NEL-00-0141

Joseph M. Farley Nuclear Plant
Reactor Vessel Support Concrete Temperature
Reply to NCV 50-348, 364/00-01-01, Failure to Identify an USQ

Attachment 1
Response to
NCV 50-348, 364/00-01-01, Failure to Identify an USQ

Review of NRC Letter "Evaluation of Task Interface Agreement 98-11"

PLAN @ REACTOR VESSEL SUPPORTS

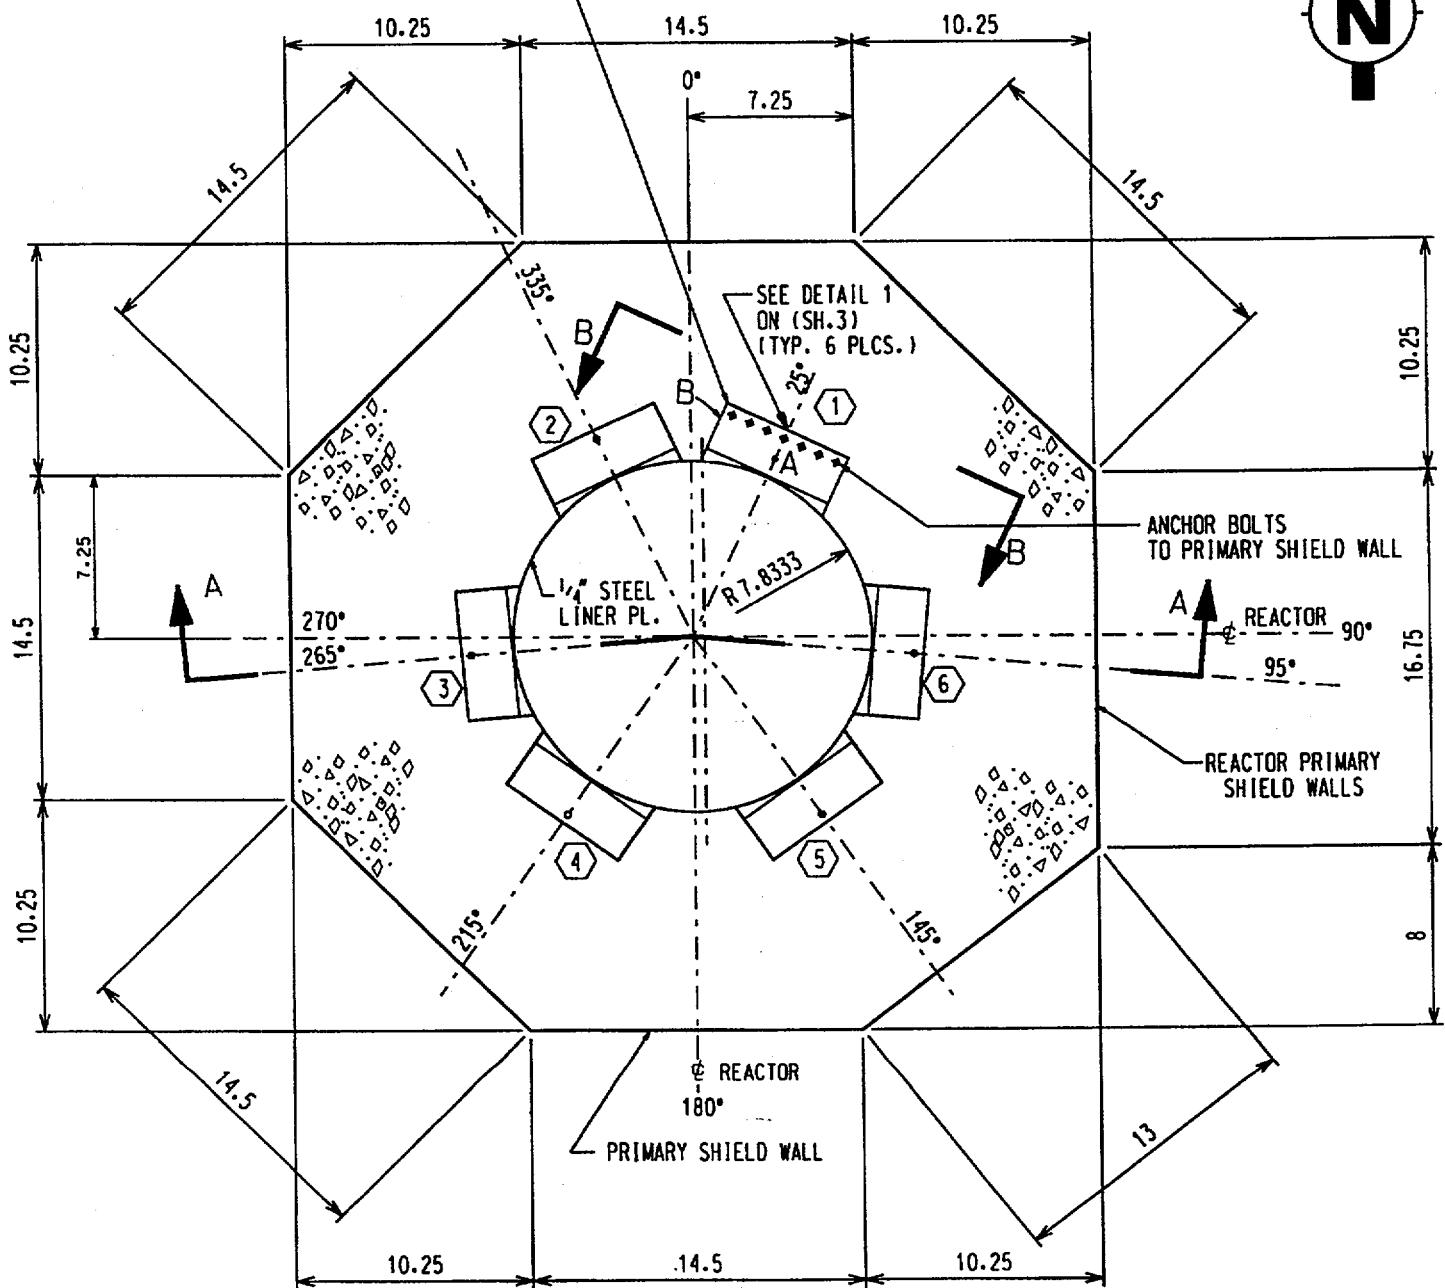
The Reactor Pressure Vessel (RPV) rests on six steel supports which are located underneath the RPV nozzles. There are six supports; one support for each of the three hot leg nozzles and one support for each of the three cold leg nozzles. Each nozzle support consists of two parts, one part (the upper part) which is attached to the nozzle and the lower part which supports the upper part and is in turn supported by the concrete primary shield wall. The lower part is anchored into the concrete primary shield wall. The upper part is allowed to slide on the lower part to allow for thermal expansion of the RPV. The load path from the RPV is the nozzle support upper part through the lower part to the concrete surface. The gross cross-sectional area of the primary shield wall is approximately 835 square feet, as compared to sum of the footprint areas of the six supports, which is approximately 76.6 square feet. Based on these areas, the supports occupy less than ten percent of the cross-sectional area of the primary wall.

SECTION B-B

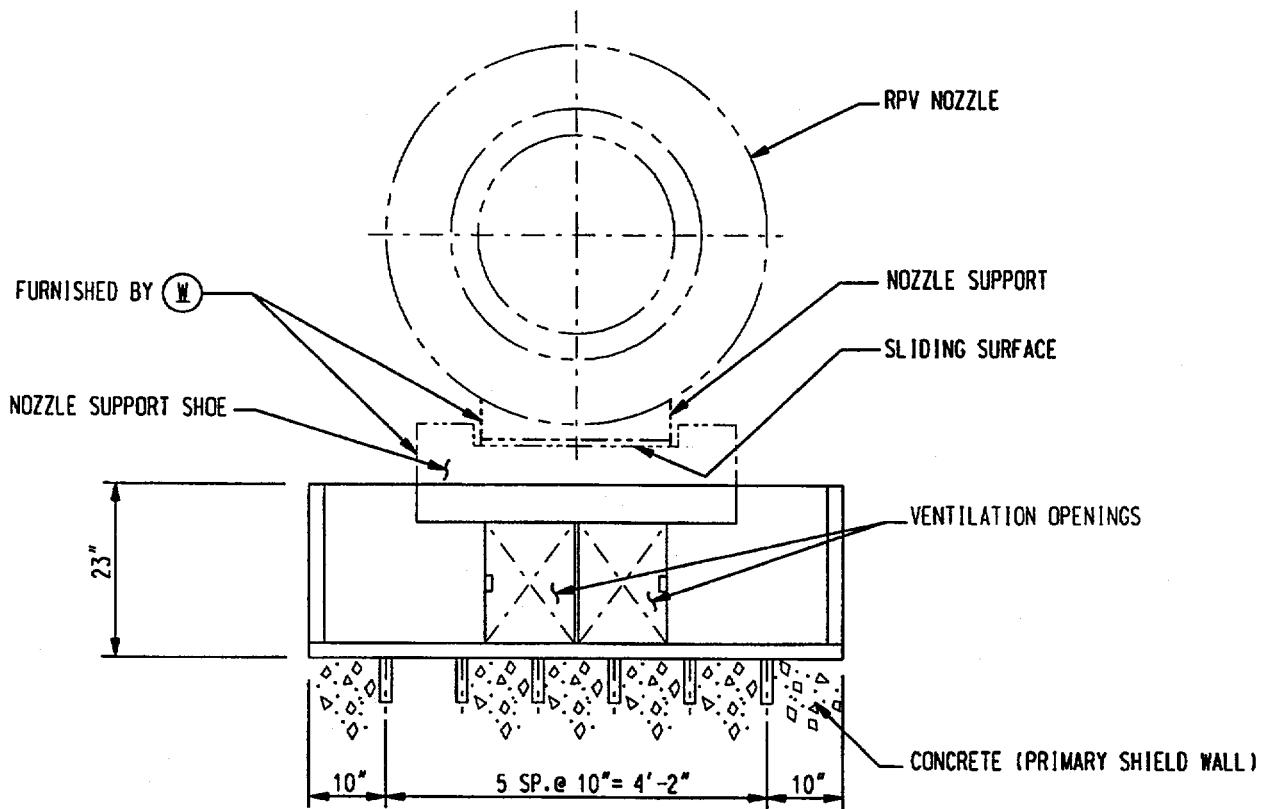
APPROXIMATE FLOW PER SUPPORT BASED ON ORIGINAL STARTUP TESTS		
SUPPORT NO.	FLOW (CFM)	PEAK CALCULATED TEMPERATURE °F
1	≈ 2150	≈ 183
2	≈ 2600	≈ 165
3	≈ 4700	≈ 120
4	≈ 3250	≈ 140
5	≈ 2700	≈ 160
6	≈ 2000	≈ 190

We conclude that the peak calculated local concrete temperature of 190°F at the support base/concrete interface is acceptable. The requirements of Subsection CC-3440 of ASME Section III, Division 2, are in agreement with the concrete temperature limits specified in Section A.4 of ACI-349-76 (1977 Supplement), and are therefore acceptable.
